# Access Compliance Report

## Public Rights-of-Way

### (Curb Ramps)

Intersection ID: 12333	Main Street: N_BREVARD_ST	Cross Street: E_7TH_ST	Location:	N
ADA ID: 72368724BE5B	Ramp Type: Perp	Initial Pass/Fail: Pass	Overall Compliance: No	Severity Score: 0.25

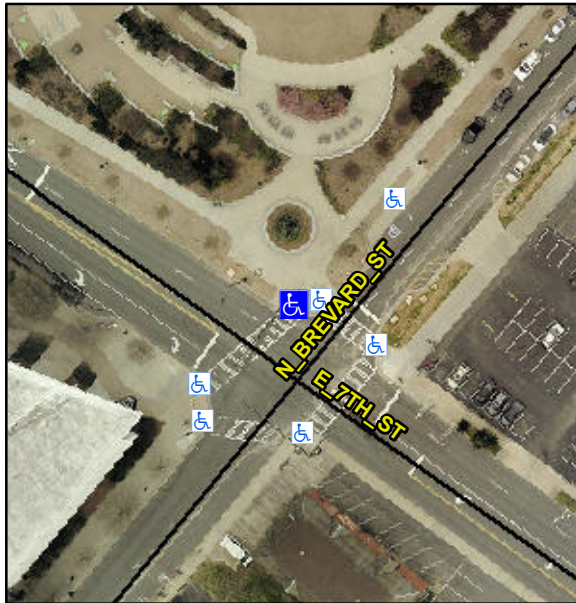
Possible Solutions:

**Remove & Replace Gutter.**

PROW/ADA:

**R304.5.3**
